6 April 2011

Re Council Resolution – Modification to Amend Stage 3 of Masterplan (MP06_0046 MOD 3)

On behalf of Bonnyrigg Partnerships, we wish to respond to the matters raised by Council in their correspondence dated 4 April 2011.

FIGURE 1 – TARGET PRICE POINT

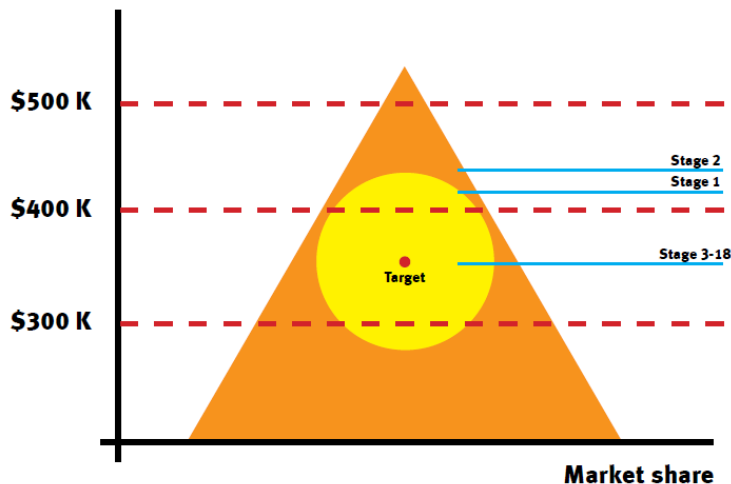
- **Improve affordability** – a target price point has been set to guide an improvement in the affordability profile of future dwellings (refer to **Figure 1**). In order to improve affordability, it is proposed to incorporate compact lots for detached and 2-attached dwellings which will still achieve the residential amenity controls outlined in the Bonnyrigg Masterplan but at a more desirable price point (refer to **Figure 2**). The key objective of improving affordability is to encourage an increased share of owner-occupiers within the dwellings to be made available for private sale (refer to **Figure 3**) and facilitate a more stable and sustainable population.

FIGURE 9 – STAGE 3 BOUNDARY (CURRENT AND PROPOSED)

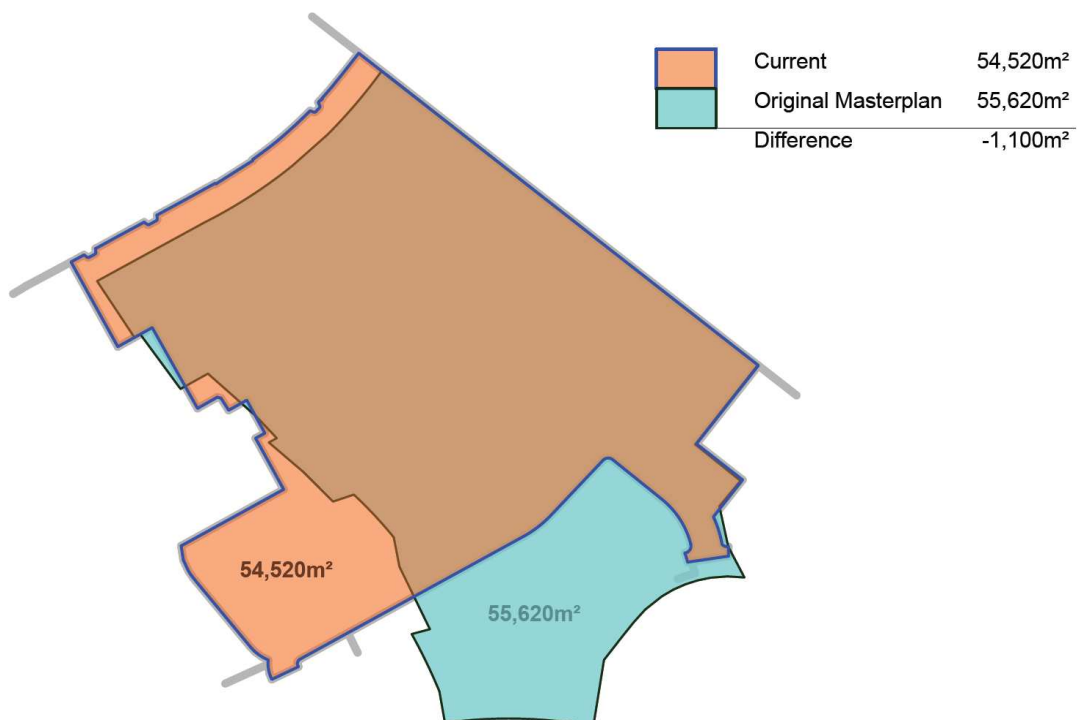
The Stage 3 development application seeks to vary from the indicative staging boundary shown on the Indicative Staging Plan. The proposed modification is required to provide an interface between Stage 3 and public open space, addressing the locational requirements for neighbourhood apartments in accordance with the amended Masterplan. However, the proposed modification to the staging boundary will result in only a minor change to the original area of this stage, as demonstrated in **Figure 9**.

The indicative yield is not proposed to change significantly in Stage 3, 159 dwellings are proposed compared to the approved indicative dwelling yield of 160 dwellings. As such, there will be only a minor change to the dwelling density for Stage 3. The average dwelling density across Stages 1-3 will be maintained as shown in the following diagram and table.

FIGURE 13 – STAGE 3 LAYOUT/SUBDIVISION PLAN

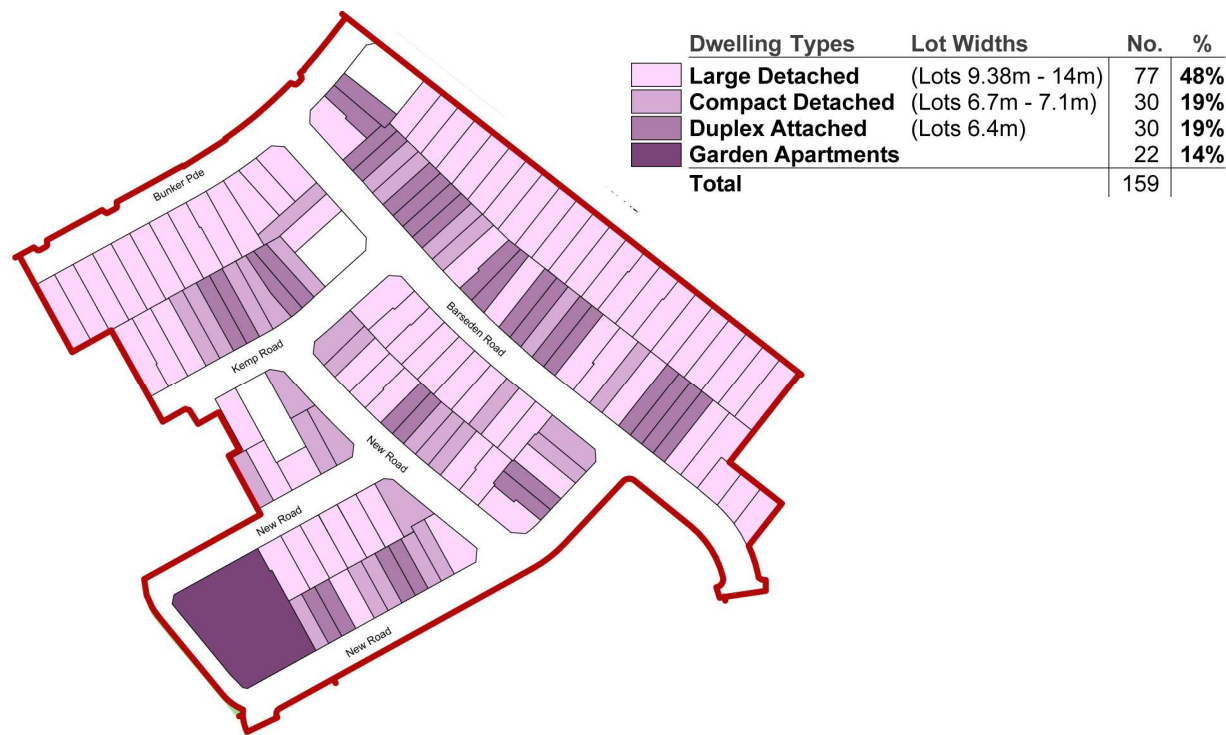
The Section 75W application and Stage 3 development application seek to introduce additional dwelling typologies, providing greater diversity in built form and increased housing choice for future residents. However, Stage 3 should not be considered in isolation - the overarching principles of the Bonnyrigg Masterplan are to provide a diversity of housing across the entire estate. It is anticipated that the delivery of housing types will change on a stage-by-stage basis, taking into account a range of issues, including proximity to the town centre, public transport and public open space, market demands and the like. Each of the stages to date can be described as follows:

The wider format housing product will generally be located on the southern side of the street, while the 'new' compact lots will be located on the northern side of the street, which benefit from north facing rear yards. This can be seen in the proposed Stage 3 layout/subdivision plan and dwelling mix (refer to **Figure 13**).

FIGURE 17 – ON-STREET CAR PARKING SPACES (STAGE 1)

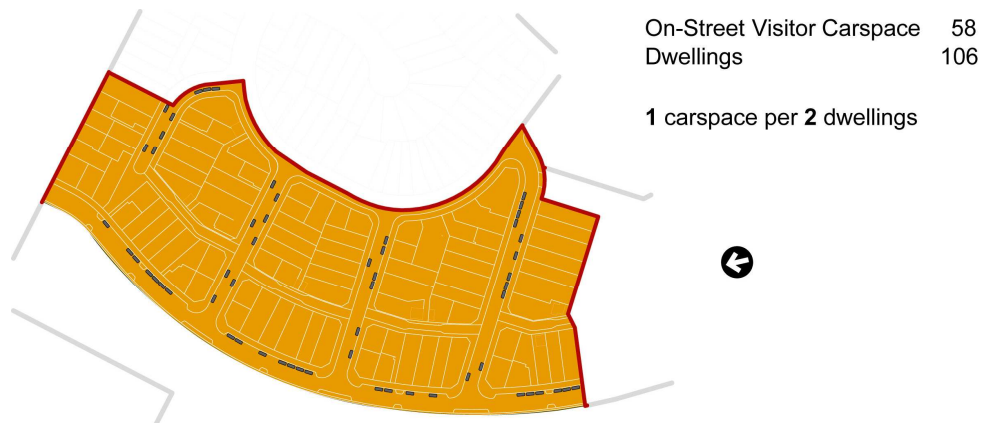
Subsequent to the above report to the Outcomes Committee, we were also made aware of potential concerns raised by Councillors regarding the potential impact of the compact lots on the amount of on-street car parking that can be achieved within Stage 3 (and future stages). In order to address Council's concerns, we undertook a comparison review of the on-street car parking within Stages 1, 2 and 3 and a survey of the actual on-street car parking demand for Stage 1, which is now fully occupied.

Diagrams indicating the capacity of each stage to accommodate on-street car parking are provided as **Figure 17**, **Figure 18** and **Figure 19**. The average amount of on-street car parking will vary from stage to stage, having regard to the retention of the existing local roads and the delivery of new roads. It is clearly evident that the proposed introduction of the compact lots and walk-up apartments will not result in a reduction in the amount of car parking, taking into account:
